No. 96-2

Water In Fuel Module (WIF) Warning Light

MCM/MIE D7.3L/270 Diesel Engines

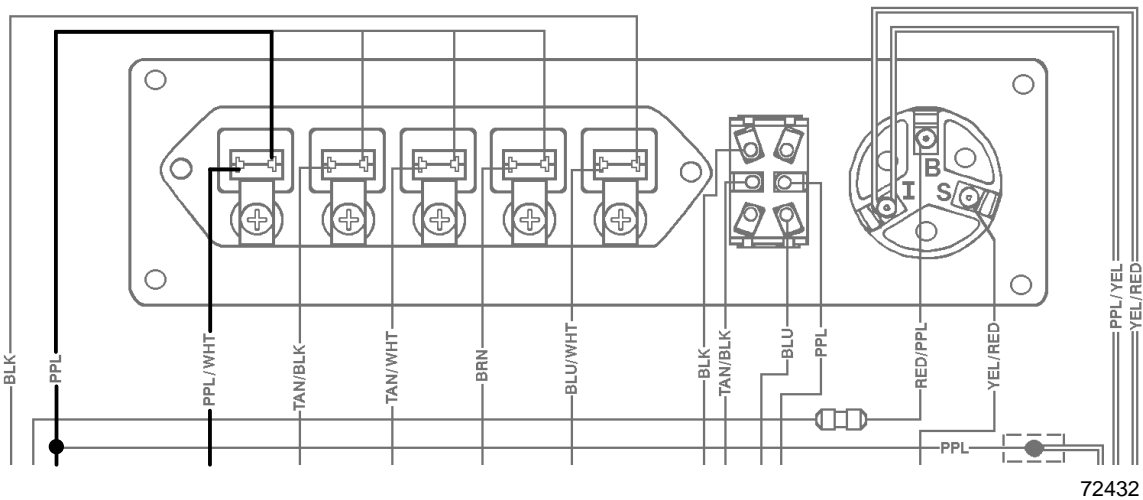
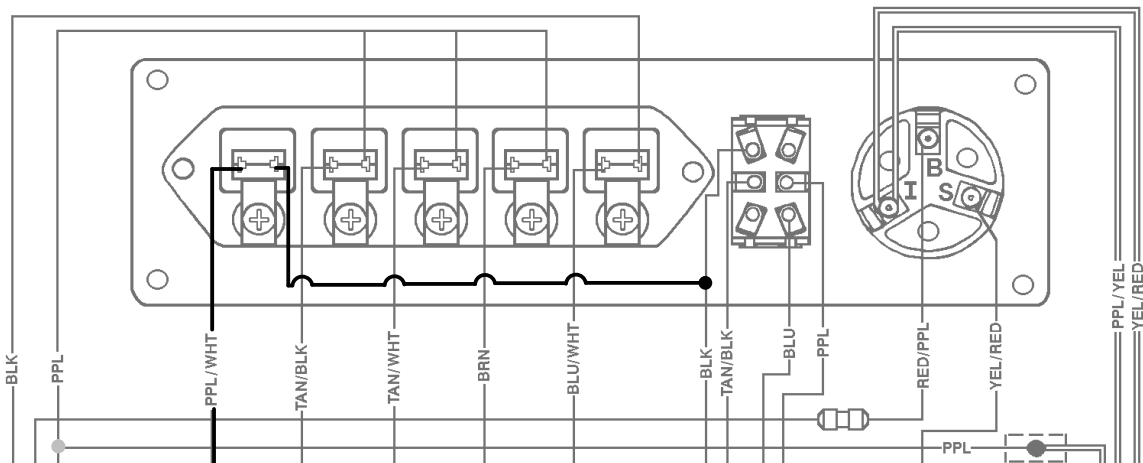
The warning light on the Engine System Monitor Panel may not operate correctly.

Change wire on WIF light on Engine System Monitor Panel as shown.

Current Wiring Set Up

Correct Wiring Set Up
